INDIANA UNIVERSITY
CAPITAL PROJECTS

Addendum #4

Project: Jacobs School of Music - Musical Arts Center Theatrical Systems –
Stage Floor, Stage Automation, Fly Automation - Design and Installation

Date: April 30, 2026

Figure 2. US Auto Batten Drives

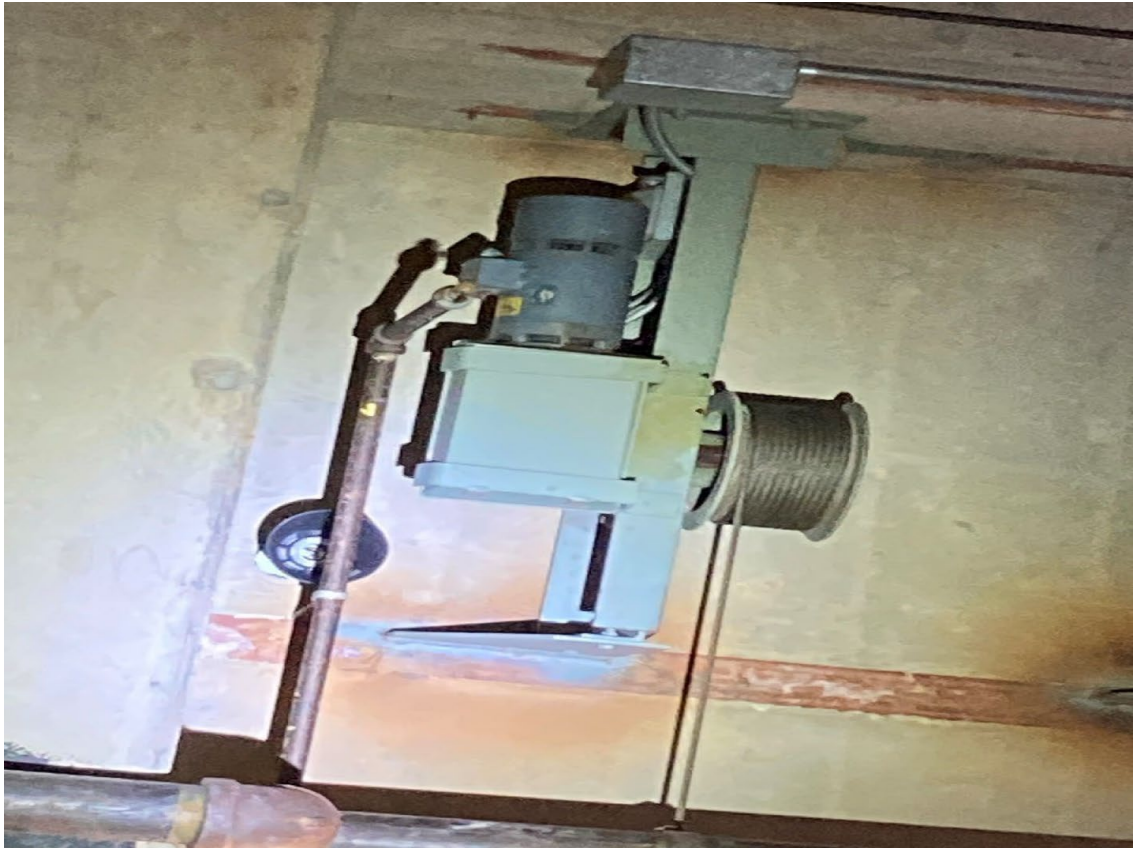
6. What are the specs of the current upstage auto battens?

Batten Length: 66' 4"

Pipe: 2" schedule 40

Pick Points: 5 spaced 13'6" +/- apart with 7' batten overhang at the ends

Lift lines: 1/4" Aircraft Cable

Travel Speed: 6 feet at 10 seconds or .6 feet a second.

Control panel is push button up and down, mounted to the DSL wall. Unable to access the motors and cannot find specs on them but from their size I am assuming they are 5 HP 208 volt connected to a right-angle worm gear reducer that turns a cable drum roughly 1' to 1' 6" Dia.

The motors have a single line attached to the drum that feeds to a clew that connects to the 5 1/4" lift lines. The track that the clew runs along is mounted along the ceiling in line with the batten and the lift lines double back at the opposite end of the system.

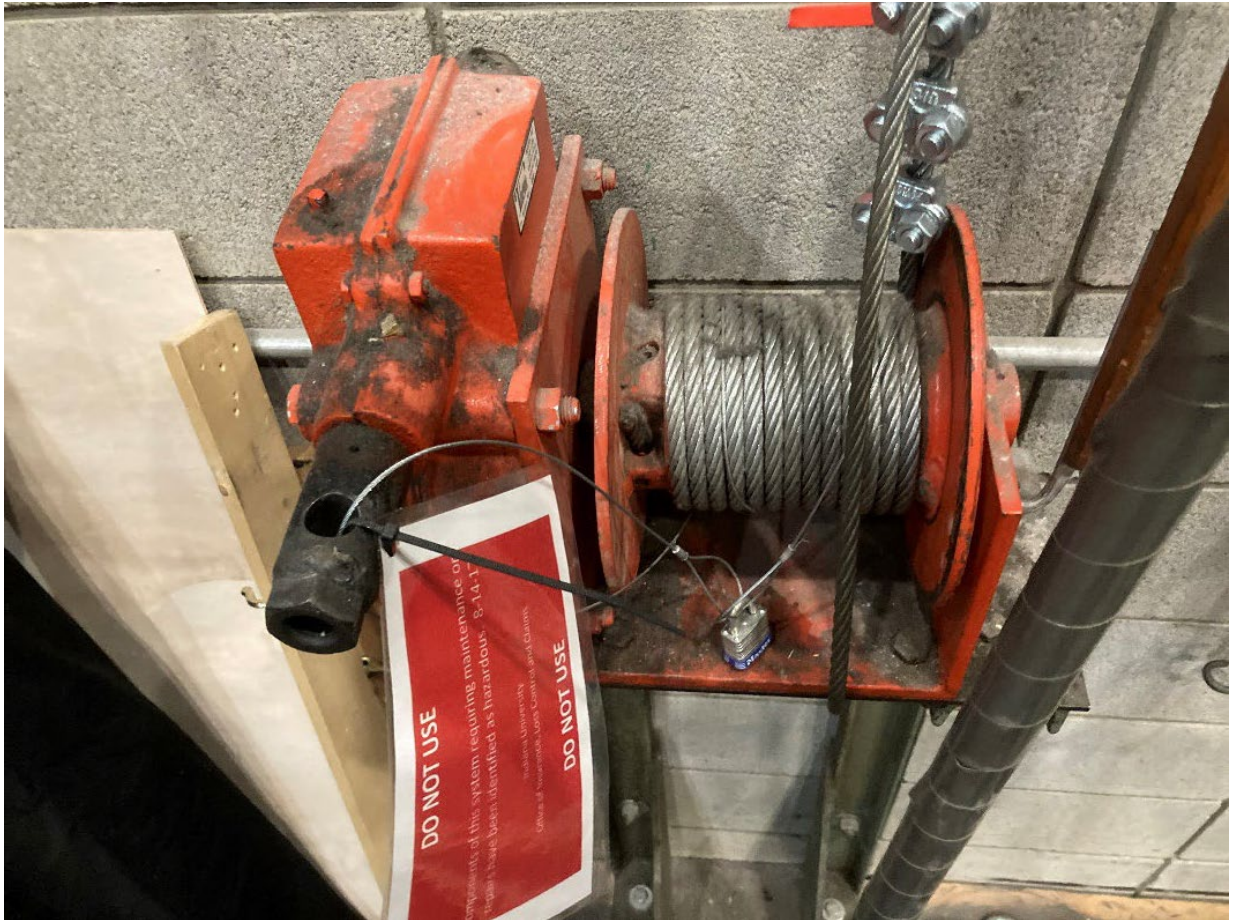
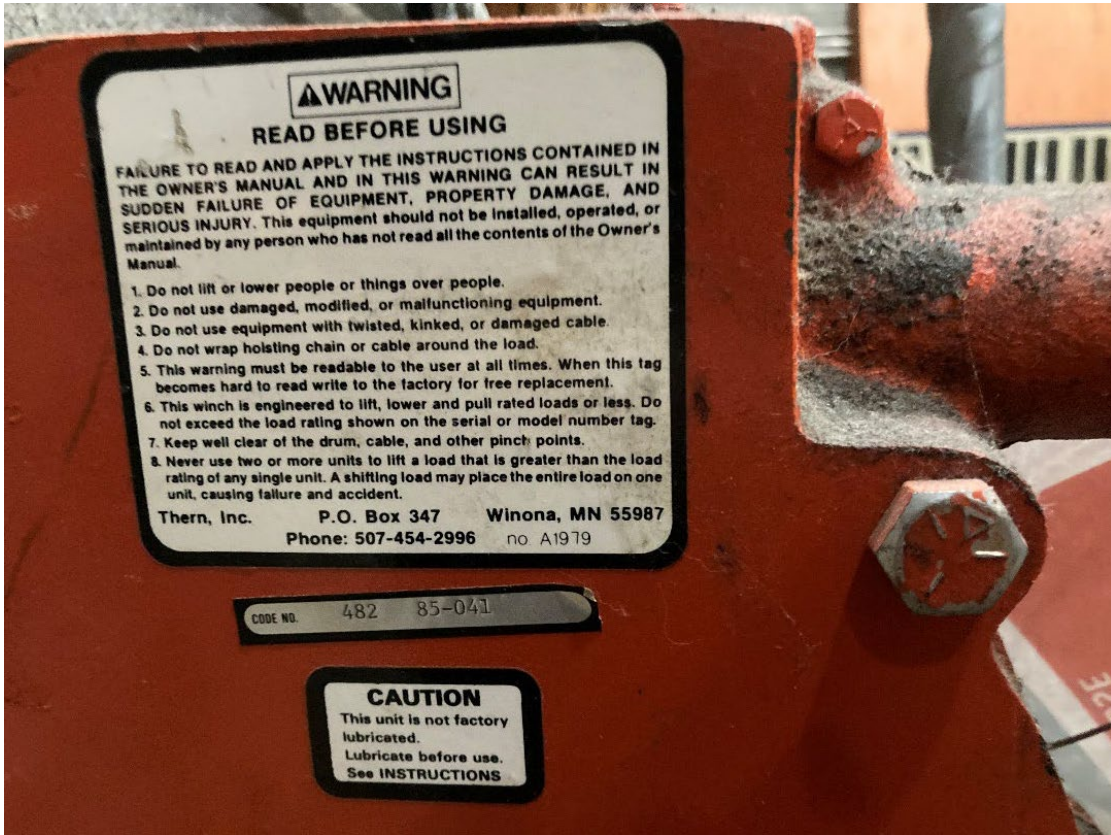
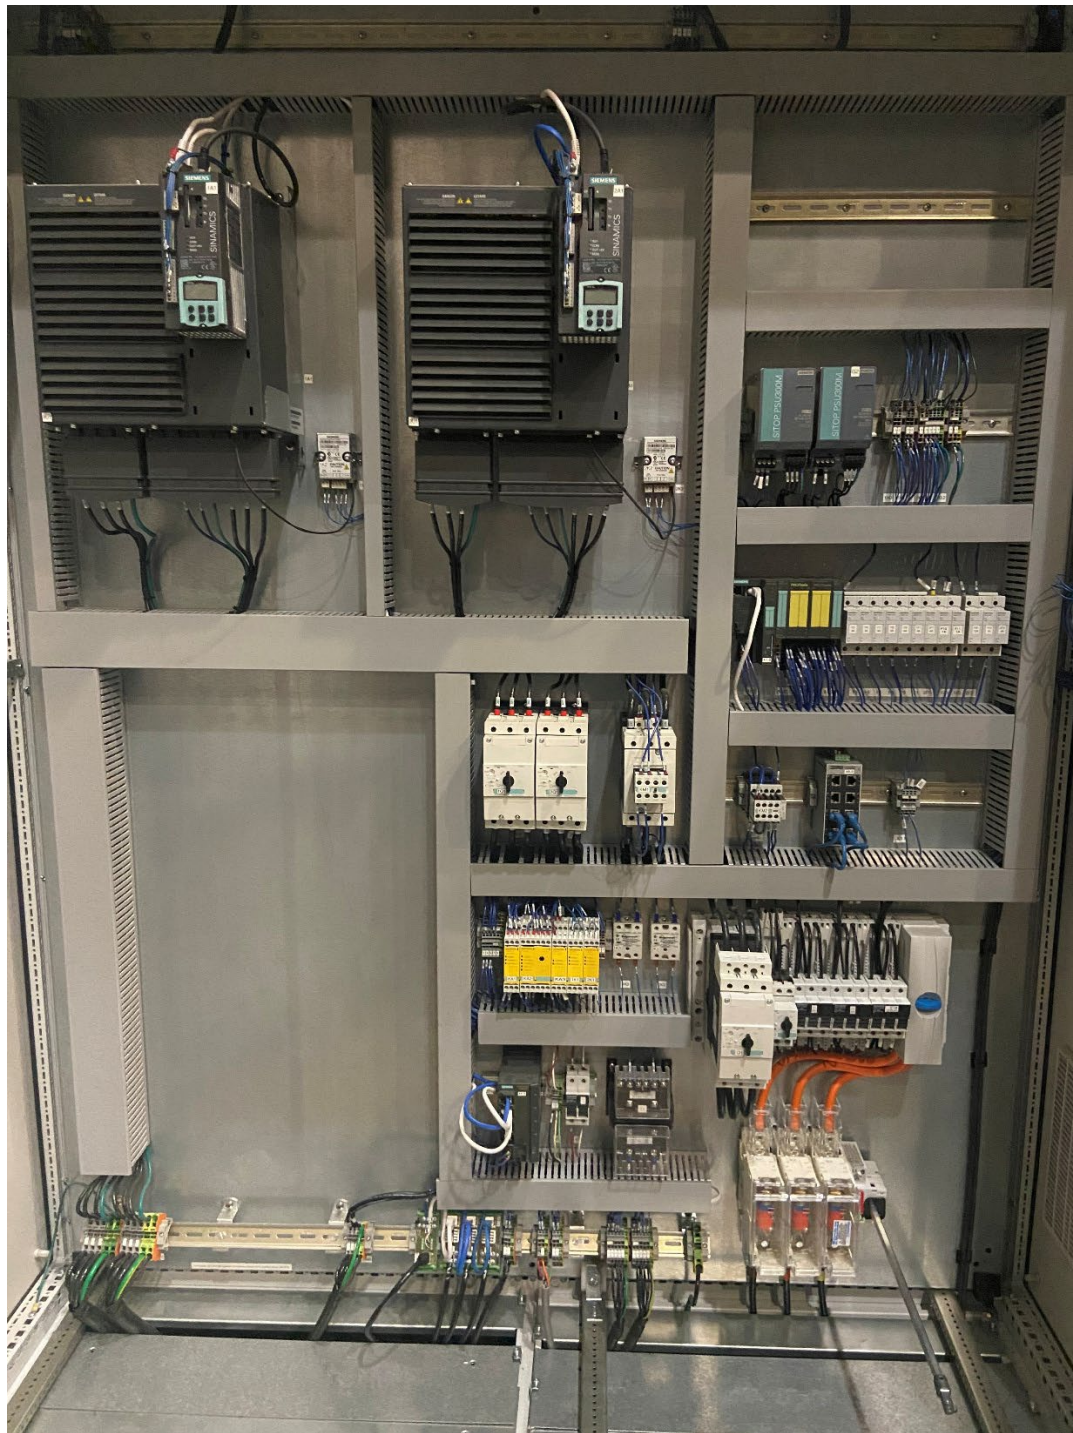
7. What are the specs of the current hand-crank winches at stage level?

Winch type: Thern product

Lift rating: 4000 pounds empty drum and 2000 pounds full

Batten length: 44'+/-

Pipe Size: 2" sched 40

Pick Points: 4

Lift Lines: 1/4" Aircraft Cable

Winch Line: 3/8" Aircraft Cable

All are double purchased. Clew winches have a single 3/8" cable running to a snatch block that travels along T tracks mounted to the wall. 1/4" aircraft cable runs through the blocks and to the battens. The track is mounted roughly 11' above the winch.

Each stage space (US, SL, SR) has one system mulled around an obstacle. The mulling only happens to the single 3/8" cable running between the winch drum to clew.

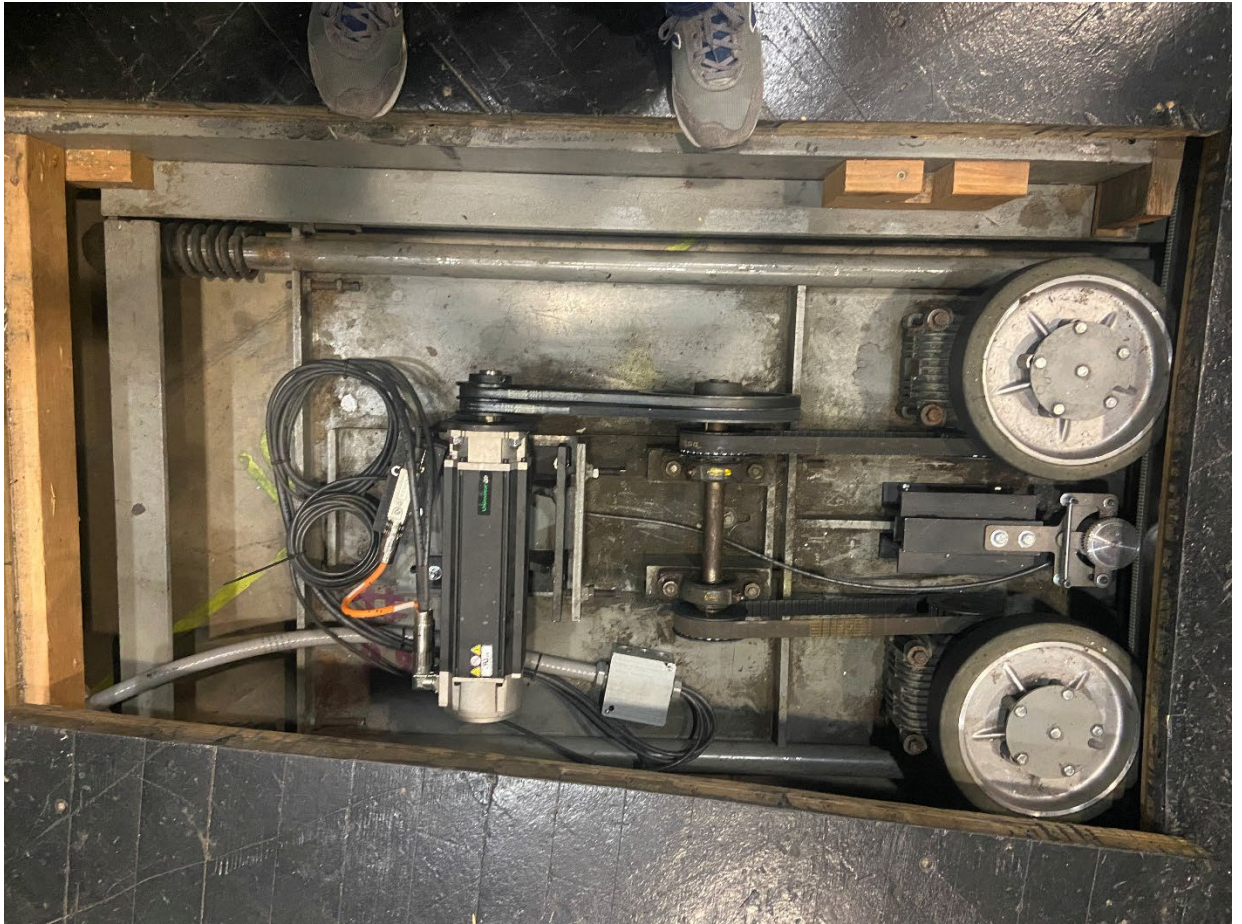
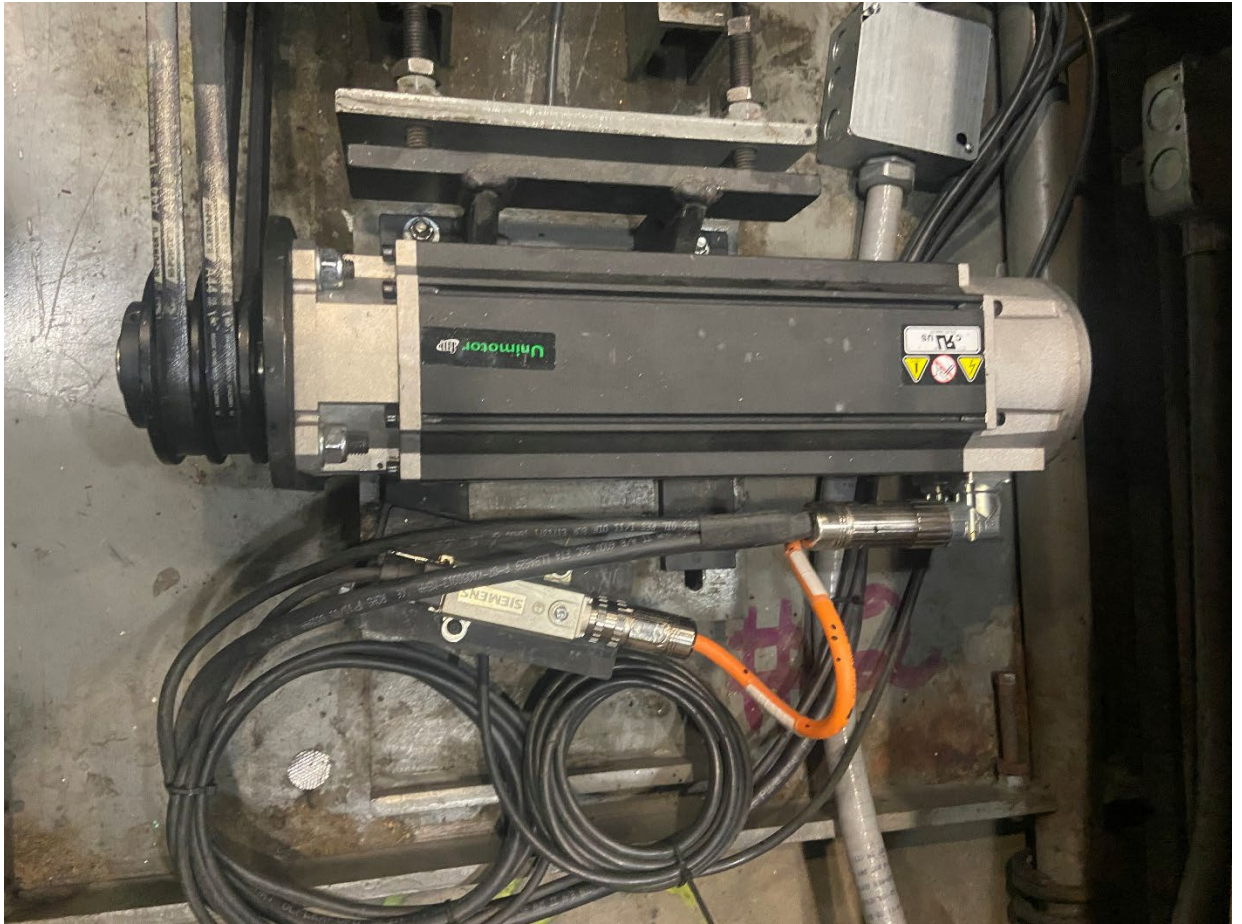
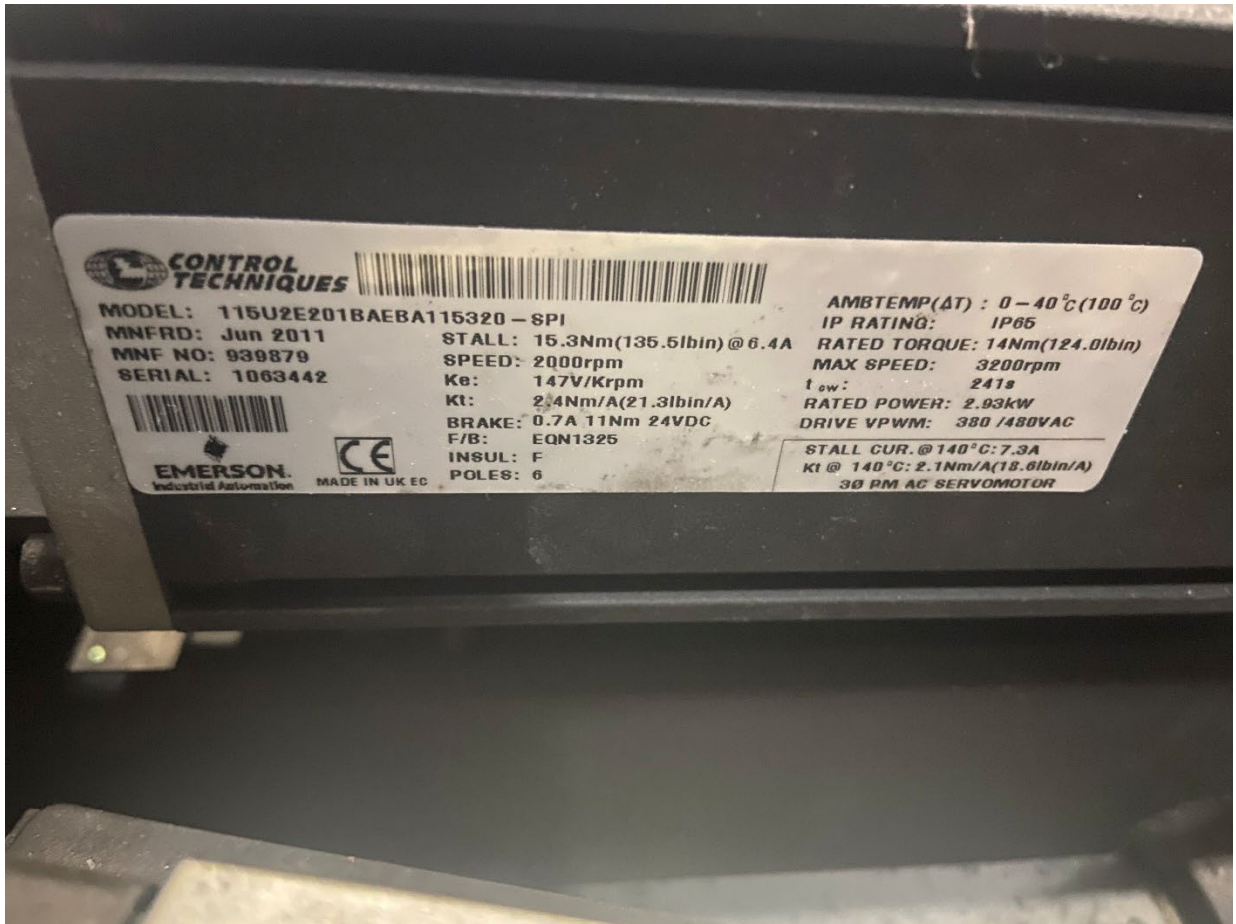
12. Do you have any pictures of the current turntable drive?

Yes. See below.
